**Landscape Review Committee**  
**Community Development Center, 231 NE 5<sup>th</sup> Street**  
**ZOOM Online Meeting: <https://mcminnvilleoregon.zoom.us/j/518962842>**  
**April 15, 2020 - 12:00 PM**

DATE: April 15, 2020  
TO: Landscape Review Committee Members  
FROM: Jamie Fleckenstein, Associate Planner  
SUBJECT: Agenda Item 4A – Landscape Plan Review Application (L 31-19)

**DECISION, CONDITIONS, FINDINGS OF FACT AND CONCLUSIONARY FINDINGS FOR THE  
APPROVAL OF A LANDSCAPE PLAN REVIEW FOR 118 NE 3<sup>RD</sup> STREET**

**DOCKET:** L 31-19 (Landscape Plan)

**Figure 6: Proposed Landscape Plan****Attachments:**

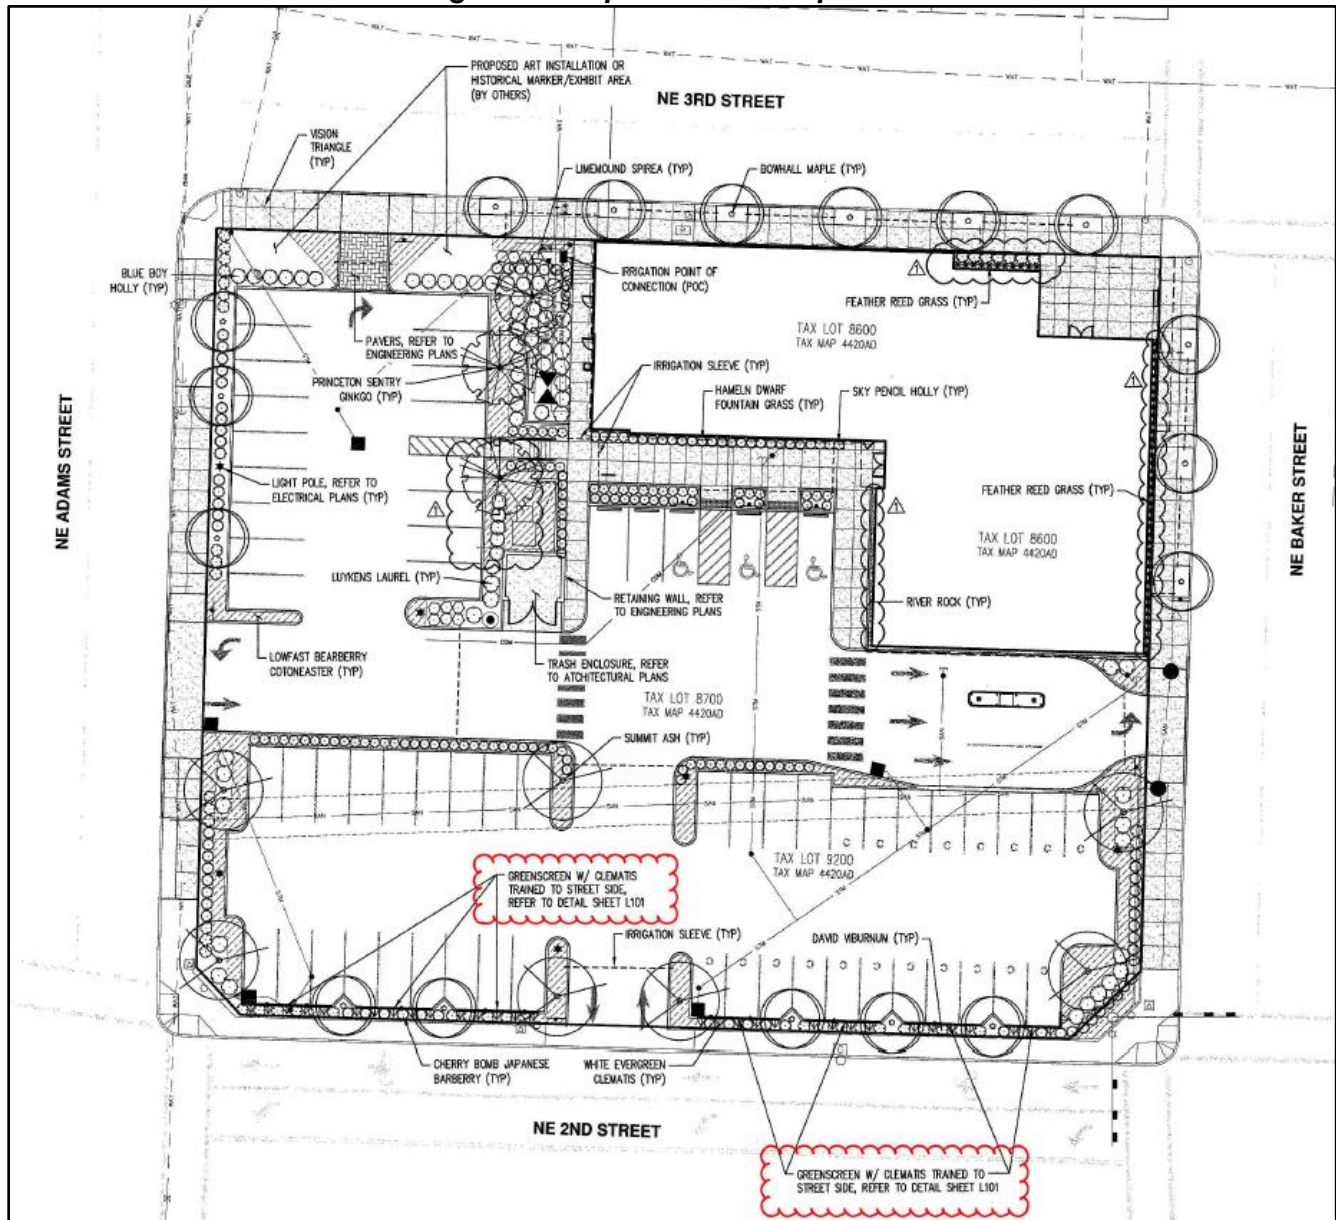
<b>Issue</b>	<b>Notes</b>	<b>Condition to Help Meet Criteria</b>
Compatibility with the project and surrounding properties and uses	<ul style="list-style-type: none"> <li>Landscaping proposed around site and parking lot perimeter provides shade, interest, and buffering to key areas</li> <li>Street trees and on-site landscaping is consistent with surrounding downtown properties</li> <li>Historic/Art Area still undefined</li> <li>Some parking lot landscaping may obstruct vision clearance</li> <li>Utility locations differ from what is shown on plan</li> </ul>	<p>Condition #2: Requires review of any additional landscaping proposed in Historic/Art area</p> <p>Condition #3: Limits height of landscaping within parking lot to 36" or less</p> <p>Condition #13: Requires review of landscaping adjacent to 3<sup>rd</sup> Street around final utility locations</p>

Use of suitable street trees	<ul style="list-style-type: none"> <li>Street trees required adjacent to site where appropriate, Bowhall Red Maples are proposed street tree</li> </ul>	N/A
Irrigation system or water facilities	<ul style="list-style-type: none"> <li>Landscape areas to receive automatic irrigation system</li> </ul>	N/A
Tree removal requires City approval	<ul style="list-style-type: none"> <li>Removal required as part of approved site plan</li> </ul>

1. That the applicant shall install landscaping as shown on the landscape plan and details, Sheets L100 and L101 with revision date January 24, 2020, and shall comply with required conditions of approval.
2. That any additional landscaping proposed within the "Historic/Art Area" be submitted for review and approval by the McMinnville Landscape Review Committee.
3. That vegetation within the planter on the south side of the internal east/west drive aisle be 36 inches or less in height to maintain clear vision between internal drive aisles.
4. That landscaping be provided around a third side of the trash and recycling enclosure. Climbing vines and screening shrubs are appropriate, and plant material must be a minimum of three (3) feet in height at the time of planting.

5. That the species and locations of the nine (9) proposed street trees is approved if and only if Street Tree Removal application L 6-20 is approved authorizing the removal of all four (4) existing street trees within the NE Baker Street and NE 3<sup>rd</sup> Street rights-of-way. If the removal of any street tree within the NE Baker Street and NE 3<sup>rd</sup> Street rights-of-way in Street Tree Removal application L 6-20 is denied, then the applicant shall submit a revised street tree plan per Section 17.58.100 of the McMinnville Municipal Code for the subject site that incorporates all existing street trees to remain as well as any required replacement street trees to the Landscape Review Committee for review and approval.

13. That a revised landscape plan for the landscape area west of the building, east of the parking area, and adjacent to the 3<sup>rd</sup> Street right-of-way, incorporating the final locations of water and electric facilities as approved by McMinnville Water & Light shall be submitted to the Planning Department for review and approval.

Figure 6: Proposed Landscape Plan

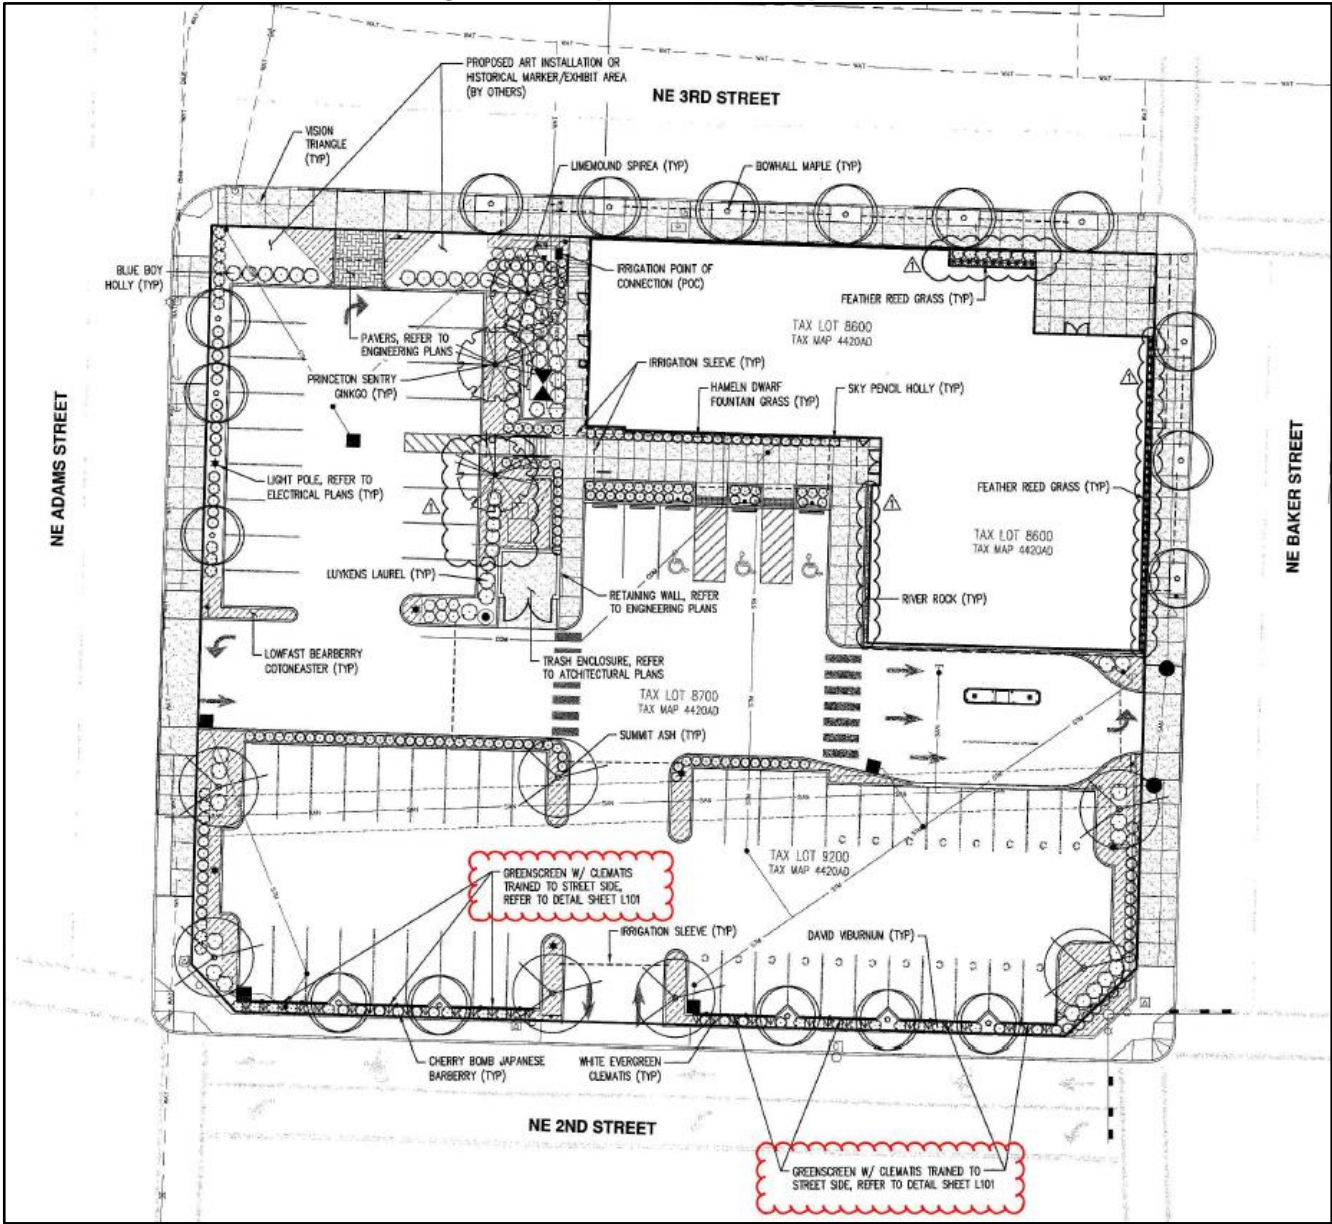
Upon review of the proposed landscape plans, we unable to approve them from the Water Engineering Department. The drawing does not reflect the changes to the water facilities. The water facilities are located completely different than shown. We would highly suggest getting with the Architect and Civil Engineer to obtain current plans, and resubmitting.

Clearances from MW&L's facilities must be maintained as indicated in our Specifications – VAULTCLEAR and WMCLEAR. These are attached for your convenience as well as a marked up drawing.

The location of electric facilities west of the new building and south of NE 3<sup>rd</sup> Street have not be finalized. Landscaping as proposed will likely need to be modified based upon final civil drawings. See the attached drawing.

1. That the applicant shall install landscaping as shown on the landscape plan and details, Sheets L100 and L101 with revision date January 24, 2020, and shall comply with required conditions of approval.

13. That a revised landscape plan for the landscape area west of the building, east of the parking area, and adjacent to the 3<sup>rd</sup> Street right-of-way, incorporating the final locations of water and electric facilities as approved by McMinnville Water & Light shall be submitted to the Planning Department for review and approval.

**Figure 8: Proposed Landscaping Around Building**

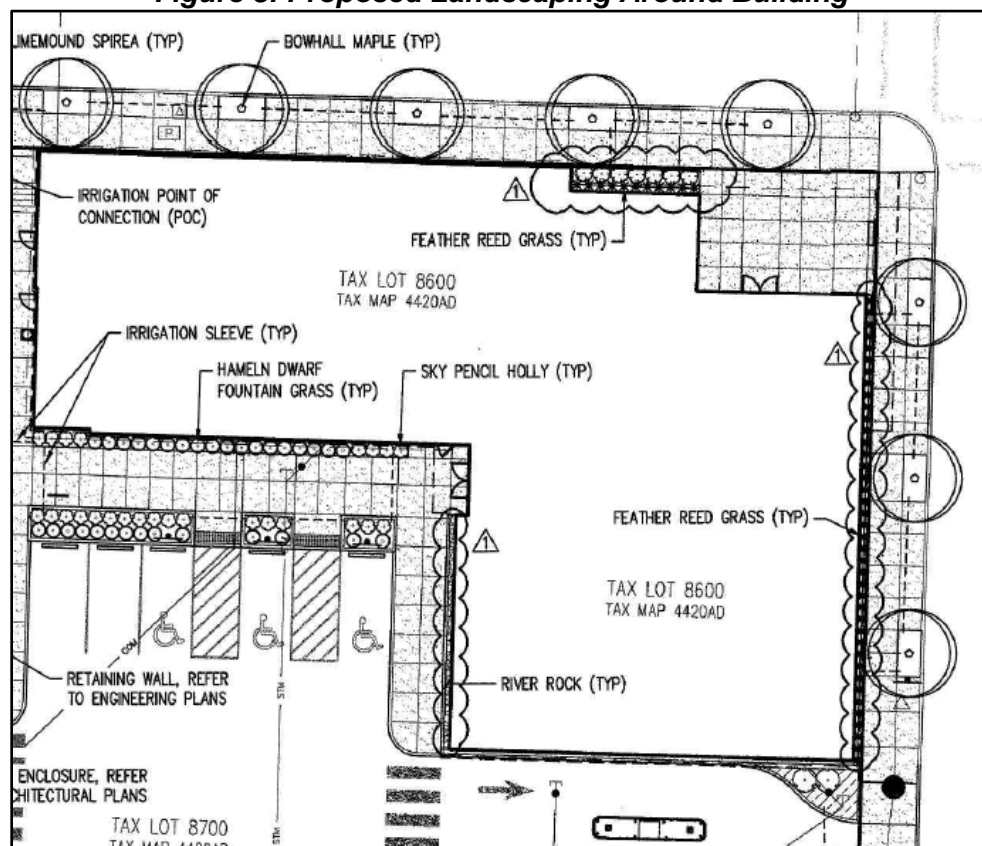
**FINDING: SATISFIED WITH CONDITION #2 AND #3.** The site plan approved by Downtown Design Review DDR 4-19 features an approximately 32,000 square foot three story building in the northeast corner of the subject site, adjacent to NE 3<sup>rd</sup> Street and NE Baker Street. Off-street parking lots throughout the remainder of the site accommodate approximately 62 vehicles, and drive-through lanes for drive-up banking. The development project encompasses the entire city block that is bounded by NE 3<sup>rd</sup> Street and NE 2<sup>nd</sup> Street to the north and south, and NE Baker Street and NE Adams Street to the east and west. Surrounding properties across the streets from the subject site are commercially zoned, like the subject site, with the exception of City Park, which is residentially zoned.

3. That vegetation within the planter on the south side of the internal east/west drive aisle be 36 inches or less in height to maintain clear vision between internal drive aisles.

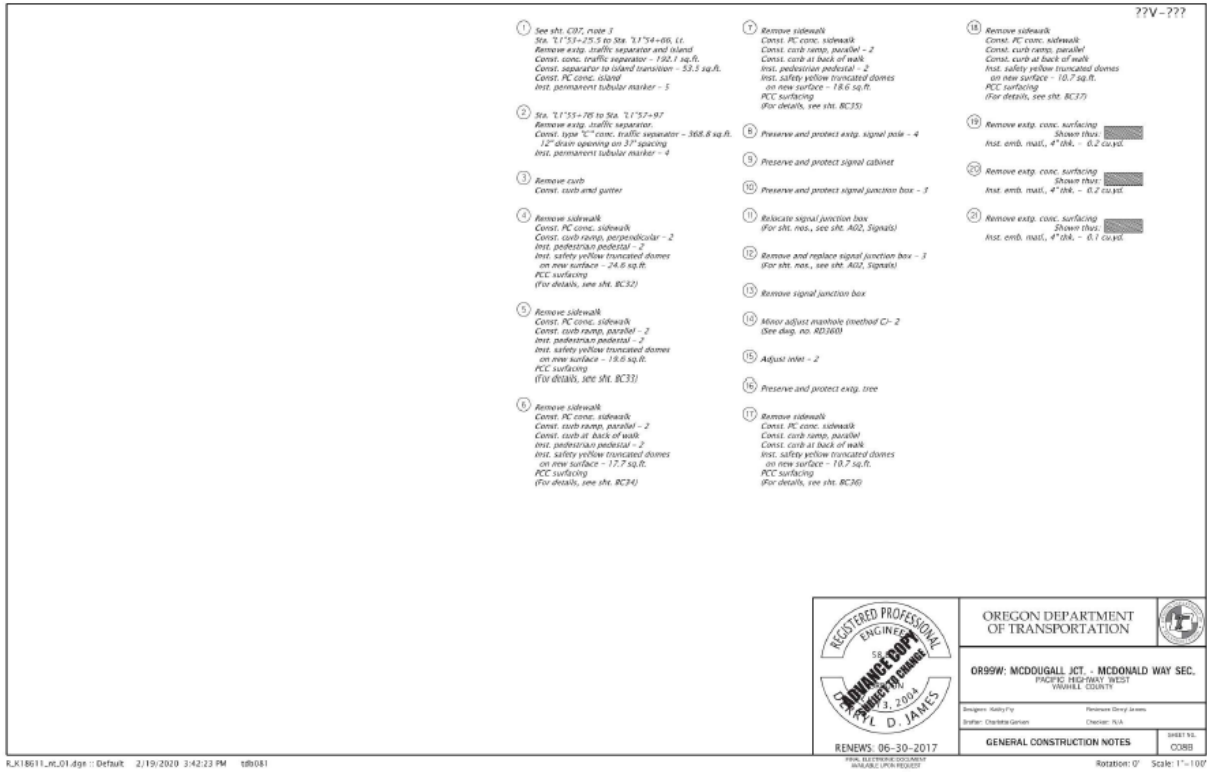
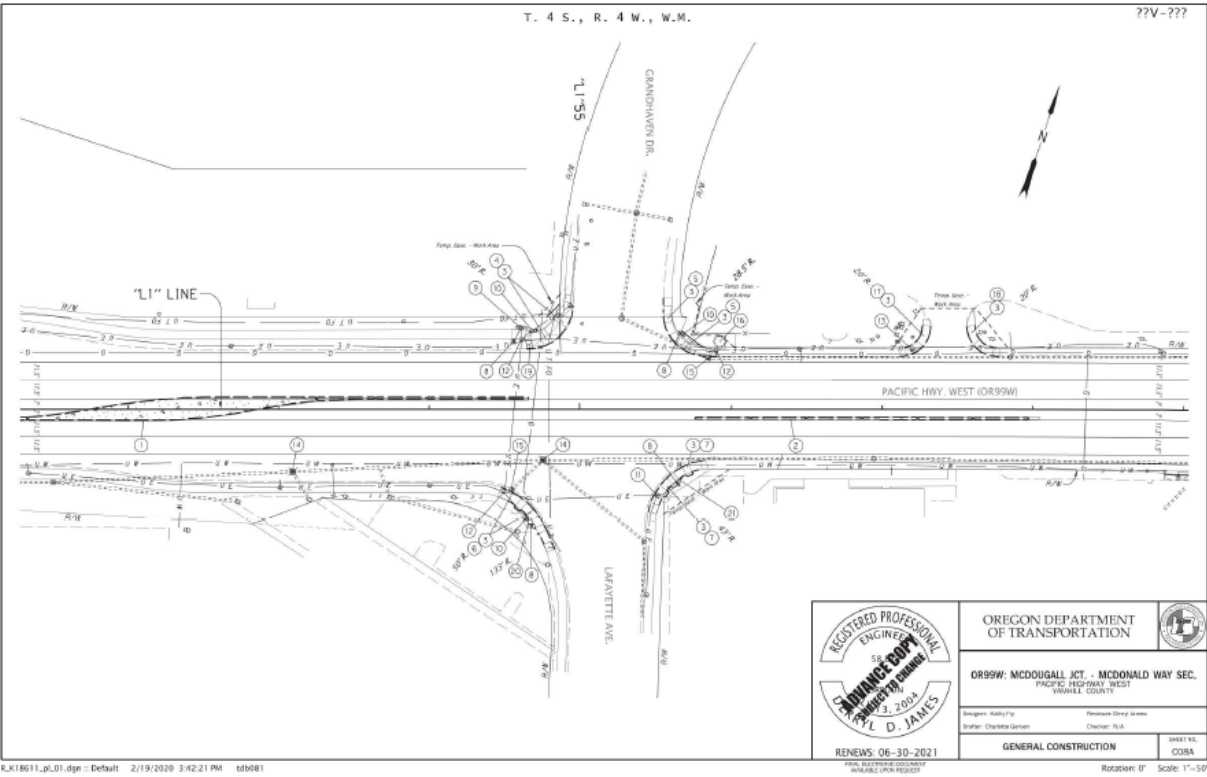
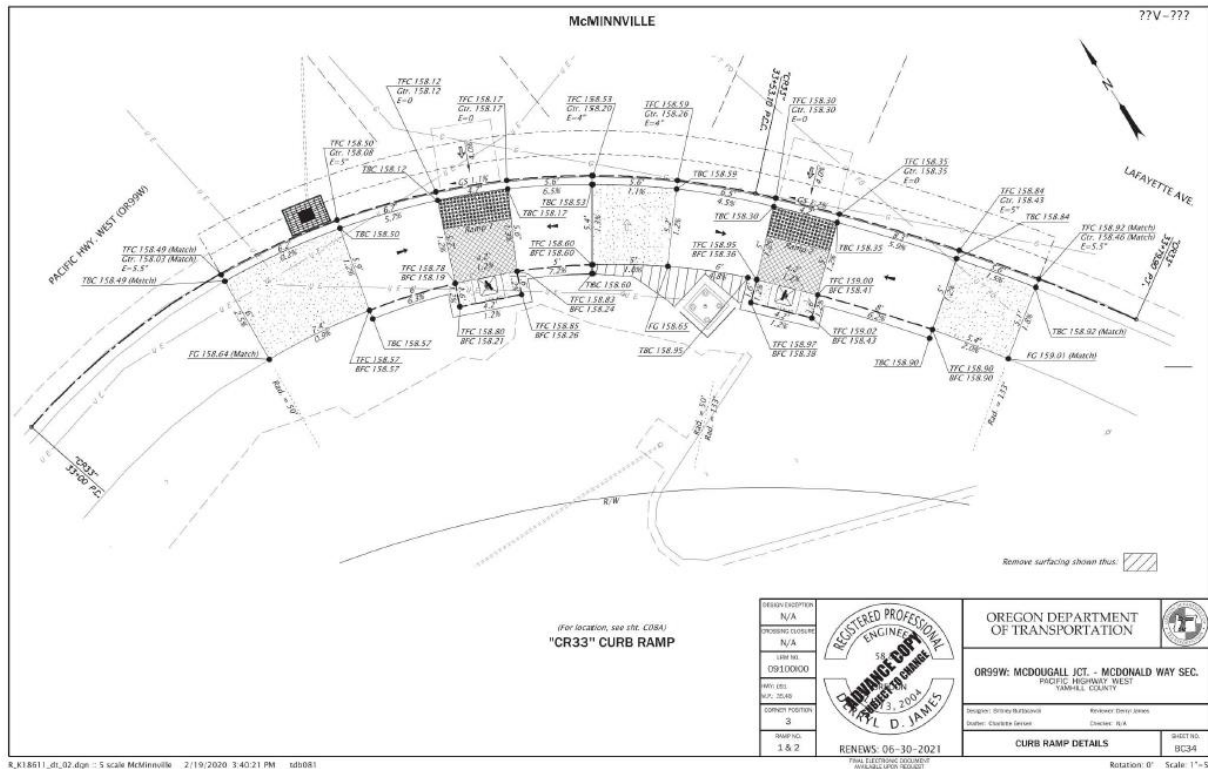
- ODOT doesn't have any issue with the remainder of the proposed landscape design, with the understanding that the portion of the design that falls within ODOT right-of-way could be altered after construction at ODOT's discretion. Generally ODOT will protect existing landscaping during construction, but space constraints might cause sections of the planting to be removed to accommodate construction needs.
